Access Compliance Report

Public Rights-of-Way

(Curb Ramps)

Intersection ID: 10033082	Main Street: NORTH_REA_PARK_LN	Cross Street: N/A	Location: S
ADA ID: D53E5532914D	Ramp Type: Perp	Initial Pass/Fail: Fail	Overall Compliance: No
		Severity Score: 12.5

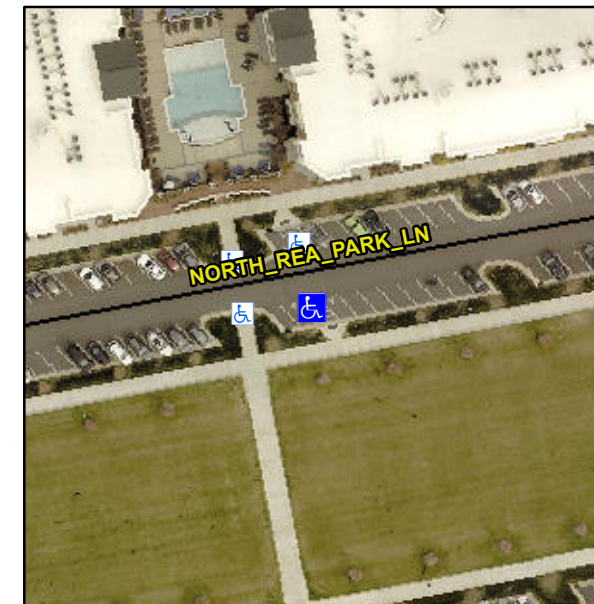
Not Found, R304.2.2

Compliance	Description	Data	Compliance	Description	Data
N/A	Ramp Length (in)	96.0	No	Ramp Slope (%)	8.4
Yes	Ramp Width (in)	60.5	Yes	Ramp XSlope (%)	0.5
N/A	Flare Type LT	N/A	N/A	Flare Type RT	N/A
N/A	Flare Slope LT (%)	N/A	N/A	Flare Slope RT (%)	N/A
N/A	Flare Traversable LT?	N/A	N/A	Flare Traversable RT?	N/A
N/A	Landing Length (in)	N/A	N/A	DWS Provided?	N/A
N/A	Landing Width (in)	N/A	N/A	DWS Contrast?	N/A
N/A	Landing Slope (%)	N/A	N/A	DWS Length (in)	N/A
N/A	Landing X Slope (%)	N/A	N/A	DWS Full Width?	N/A
N/A	Landing Curb? (Y/N)	N/A	N/A	DWS Offset (in)	N/A
N/A	Shared Landing?	N/A			
N/A	Gutter Ponding?	N/A	N/A	Gutter Slope (%)	N/A
N/A	Gutter Lip Ht (in)	N/A	N/A	Gutter X Slope (%)	N/A
N/A	Painted X Walk1?	No	N/A	Painted X Walk2?	N/A
	X Walk 1 Direction	To N		X Walk 2 Direction	N/A
N/A	X Walk 1 Width (in)	N/A	N/A	X Walk 2 Width (in)	N/A
	X Walk 1 Slope (%)	4.0		X Walk 2 Slope (%)	N/A
	X Walk 1 X Slope (%)	1.2		X Walk 2 X Slope (%)	N/A

Remove & Replace Entire Ramp.
